REVISIONS				
REV	DATE	DESCRIPTION	CHECKED	APPROVED
01	09 10 24	Building regs notes added in red	--	--
02	08 11 24	Fire officer notes added in red

CLIENT ANTHONY ROSE		
PROJECT TITLE CONVERSION OF BALBY ROAD PARK SOCIAL CLUB TO RESIDENTIAL USE		
DRAWING TITLE PROPOSED GROUND FLOOR CELLAR AND BASEMENT SITE PLAN AND SITE LOCATION PLAN		
© ANTHONY SNOWDEN ARCHITECT 2024 RIBA		
SCALE as shown		
PROJECT NO. 023	DRAWING NO. 03	REV. 02

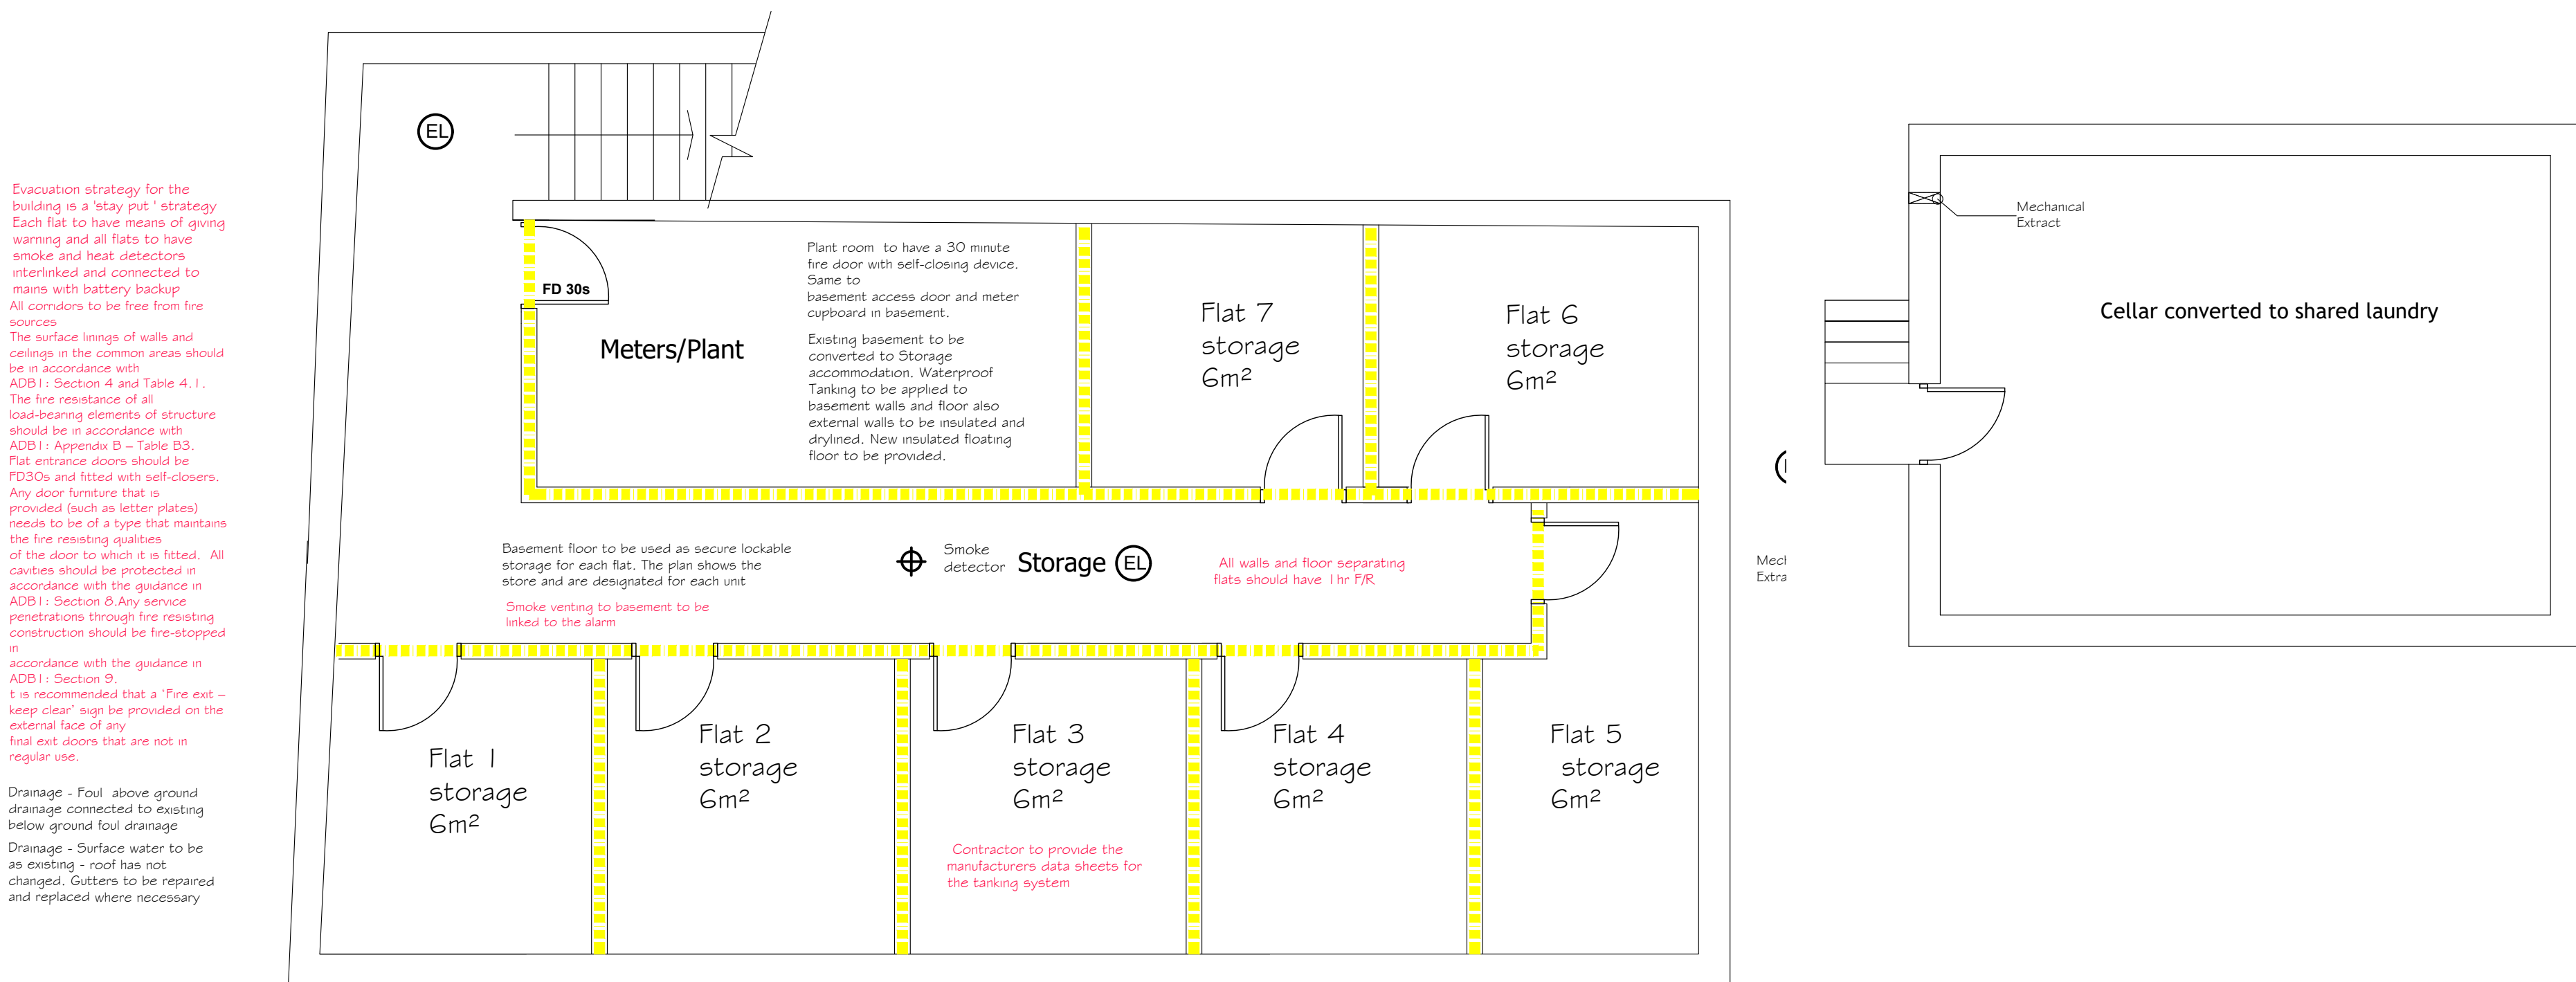
External walls provide insulation to achieve u value of 0.7 - dry line with kingspan K18 boards, 60mm thickness. Fixing methods in accordance with manufacturers recommendation. Mortar dabs or mechanical fixing

Each flat To have means for
Smoke detection interlinked
where more than one per unit
Evacuation Strateg - stay put
only flat of fire origin to evacuate

On completion of the installation the model test certificates detailed in Annex D of BS5839: Part 6 should be provided to the responsible person.

Escape Windows

All floors served by the proposed escape windows are no more than 4.5m above the adjacent ground.

Escape windows lead to a place of safety.

Improved U-values to walls to achieve a minimum of $0.3\text{W/m}^2\text{°C}$

Floors U value 0.18 to living accommodation.
Kingspan K103 100mm
allow 25mm perimeter upstand.

Roof U value 0.15 to living accommodation.
Warm roof insulation over structural deck - kingspan thermroof TR27 150mm
windows to achieve a minimum of 1.4W/m²oC.

Background ventilation (trickle vents) required to lounge extension window of 8000mm².

Staircase to consist of equal rise and going max pitch 42°
 Handrail 900 over pitch 2m
 headroom no opening in balustrade more than 100mm unobstructed width 800 tapered treads min 50mm at lowest end
